Important New Model Information—150 Pro XS FourStroke

Models Covered	Serial Number Or Year
150 Pro XS FourStroke	2B550139 and above

Silver colored gearcase

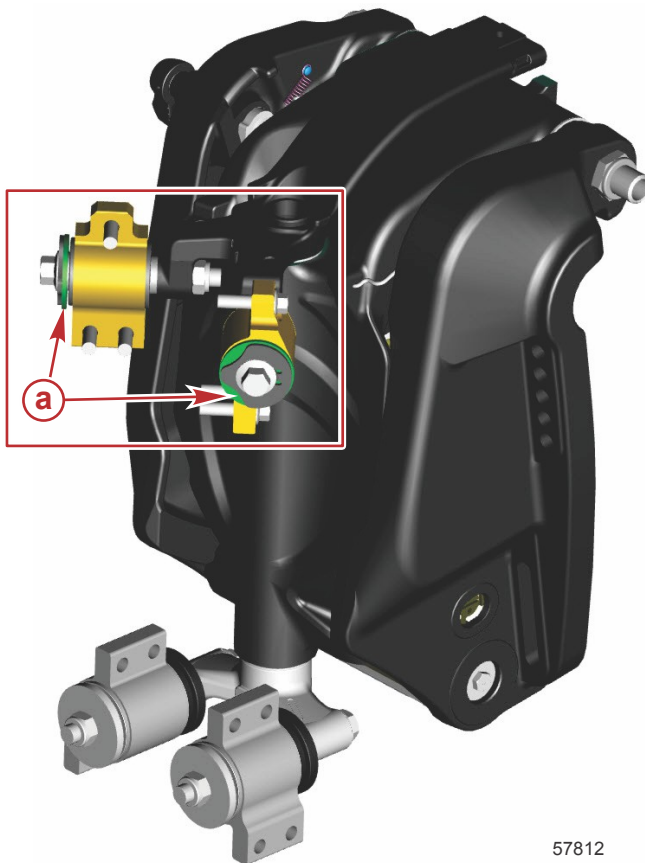
New 2.08:1 Gearcase

The 150 Pro XS is equipped with a silver 2.08:1 gearcase. This is the same gearcase ratio and design that was used on the 4-cylinder Verado product.

- a -** Side water pick-ups
- b -** Nose water pick-ups
